29 West Lancaster Avenue, Ardmore Commercial Historic District

25-15

Preliminary Consultant Review

Compiled by Carol Quigley, Senior Designer / Project Manager Frens & Frens Studio, Patterhn Ives LLC

July Update

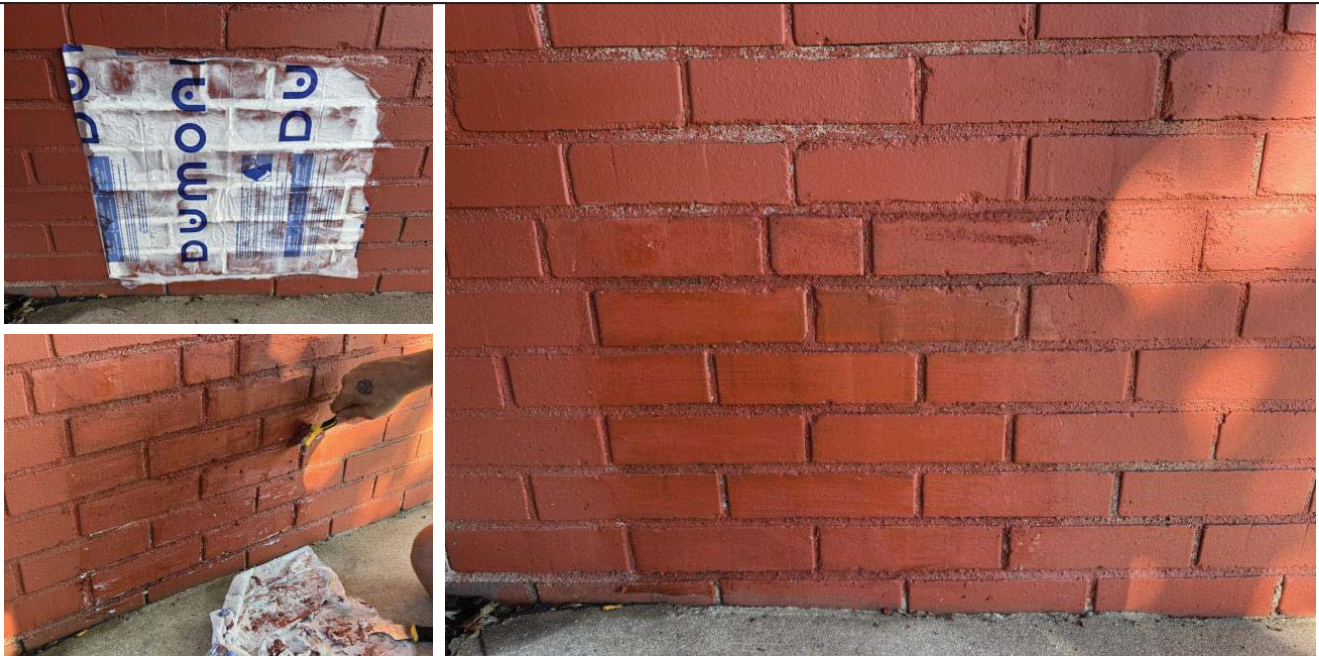
Following the initial B&P discussion of this item on June 11, HARB formally reviewed the options for mitigating the work at their July 1 meeting. HARB made a motion to have the applicant test a paint removal product on a 2-sq. ft. area. A subcommittee was assigned to evaluate the results and form a recommendation for whether the test adequately removed the paint and should be applied wherever the brick was painted.

The product was applied on July 23. The results of this test and the subcommittee's recommendation are expected to be available for the Committee's review at the July 30 B&P meeting.

Proposed Signage

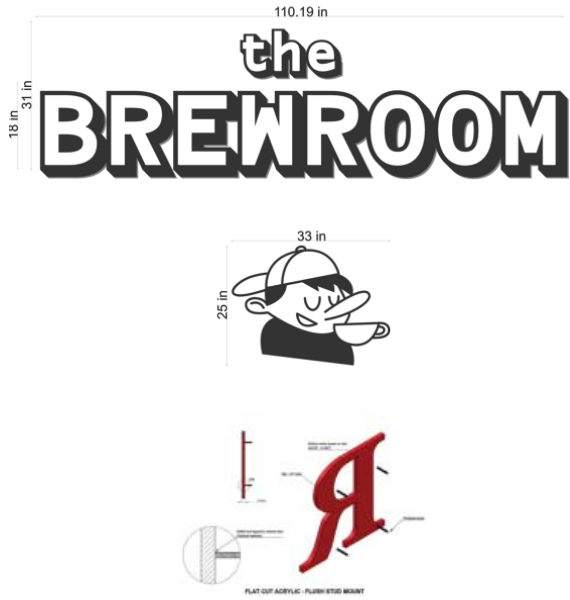
- The applicant presented a previous illuminated sign proposal to the HARB at the first July meeting and heard feedback from the HARB regarding the bulkiness of the signage components and the illumination through the front face of the channel letters. The newly proposed sign eliminates illumination and proposes installation of the 1” thick acrylic letters and 1” thick logo directly to the stucco façade. This simply installation is appropriate in the Historic District.
 - The applicant should clarify if the letters are truly individual pieces or groups of letters bundled together to form a smaller number of components (as the graphic seems to indicate).

Approval to install a non-illuminated sign consisting of an acrylic logo and letters mounted directly to the stucco façade, citing Secretary of the Interior's Standard 9.

We would recommend approval of this application in accordance with Standard 9.

Youngs Ford Road Elevation

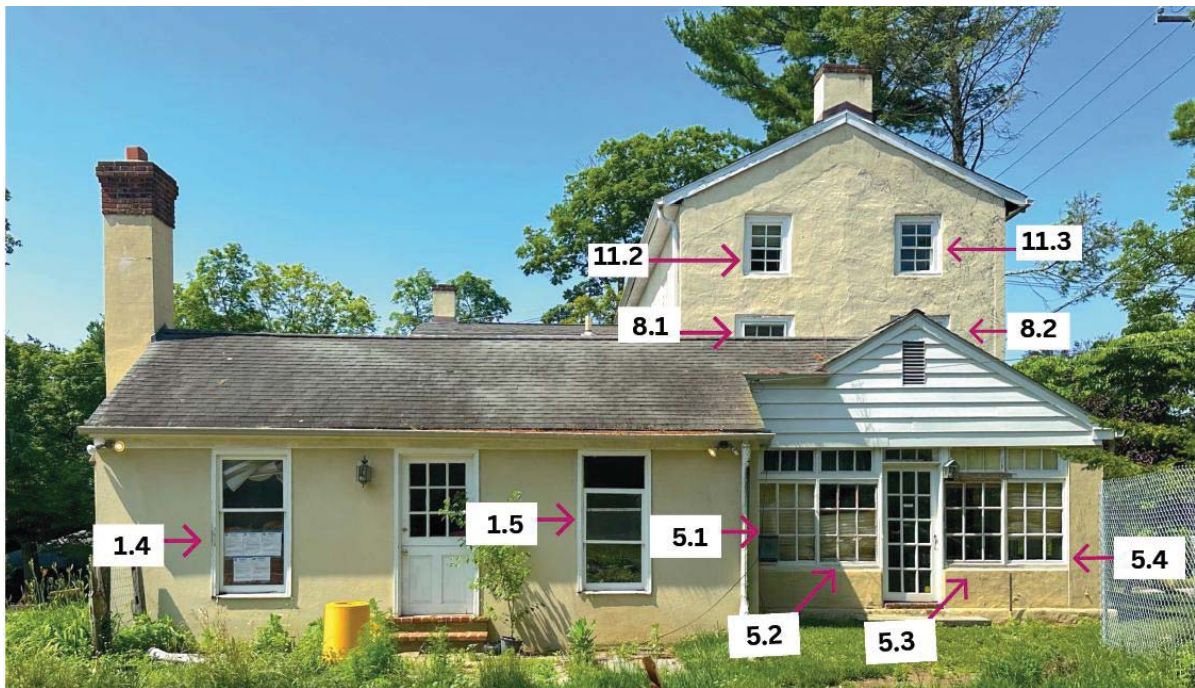
- The applicant has submitted a few pieces of information that allude to Marvin windows and doors but needs to confirm which Marvin product / series is proposed for use as replacement. Further, as requested of all window replacement applicants, the applicant should submit an elevation and section detail drawing of one of the typical existing window sash and frame coupled with a proposed replacement window sash and frame elevation and detail so that the HARB can have a full understanding of the resultant change in daylight opening with the window replacements as well as clarification on what other components of the window openings will be impacted – replaced in kind, retained or restored.

- Given the Class 1 status of this resource, it is important to further investigate the appropriate light configuration for the replacement windows. The applicant has errantly indicated a 9-over-2 light pattern at all large hung windows, but provided photographs show that the majority of them are 9-over-1 and only a few are 9-over-2. The detailed photographs also indicate that at a couple of the 9-over-2 windows, the profiles of the top sash do not match the profiles of the bottom sash, suggesting that changes have been made. Some effort should be made to determine the original window configuration so that it can be incorporated into the replacement windows.

Approval to replace historic windows throughout the residence, with a subcommittee to review window frame details and revised elevations, citing Secretary of the Interior's Standard 9.

Wall of 17 W. Lancaster Ave.

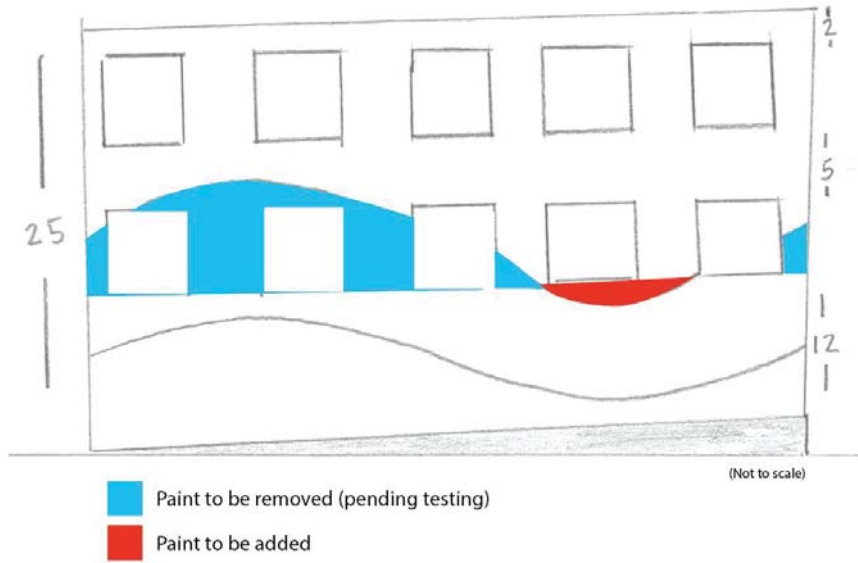
The applicant prefers a painted area with a flat top terminating at the first floor window sill rather than the present "wave" shape. Though some brick would be newly painted, the work will result in a net loss of painted brick surface.

- Proposed renovations include repointing areas of the brick walls where needed, painting over the existing waves of tan and gray paint with a full one-story height of white paint to provide a “blank canvas”; installation of multiple mural paintings on canvas to be applied to the white field, installation of string lights crisscrossing down the pedestrian alley, and adding bistro tables and planters.

- Upgrades to the decorative elements of the pedestrian alley are warranted and improve the public interest and safety in the area. Lighting of more constrained spaces such as this is always a good idea for public safety, and string lights are a common and pleasing method of doing so with minimal impact on the structures. Public art on open horizontal surfaces is also a positive element in historic districts, but in the Ardmore Historic District where painting the predominant facades of red brick is not appropriate, creating a large white field for artwork would not be appropriate either. Given the existing painted brick surface, it would be most appropriate to either test the potential removal of the existing paint, repaint the existing colors as a means of maintenance (employing appropriate coatings for the masonry application), or creating the desired monolithic “field” of the whole first story by applying an appropriate coating in a red-brick color so that it blends in with the existing brick, but still provides a uniform background for installed artwork.

Approval to renovate the "Ardmore Art Alley" between two commercial buildings, including brick repointing, repainting brick up to the first floor window sill, adherence of interchangeable canvas murals, and installation of hardware to mount string lights, with a subcommittee to provide feedback on the removal of existing paint above the first floor window sill.
